FIELD SERVICE BULLETIN

FSB Number: LVCCFSB2005-126
Author: Ross Karlen
Date: April 20, 2005
Total No. of Pages: 2
Subject: **3G V975 – Display Lens Crazing**
Phone Models: 3G V975's
Level of Repair: 2

Pic 1 Display Lens Crazing (Note: Several lines throughout the lens)

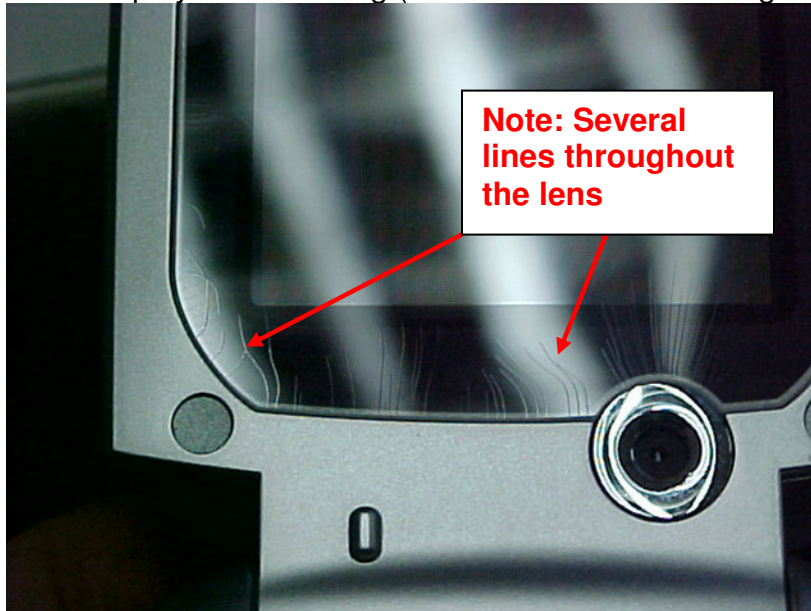
Service is aware of an issue, highlighted by Development during internal testing. Some units were found to exhibit lens crazing within 1 hour of exposure to heat between 55° and 65° C (See Pic 1). Analysis revealed a process concern during the annealing stage at the supplier. Approx. the first 80,000 units shipped may be impacted by this symptom.

Supplier changed their annealing process to resolve this issue.

1. If Crazing is identified, follow normal repair procedure for Lens replacement.
2. Follow normal troubleshooting techniques to identify failure, per customer complaint.
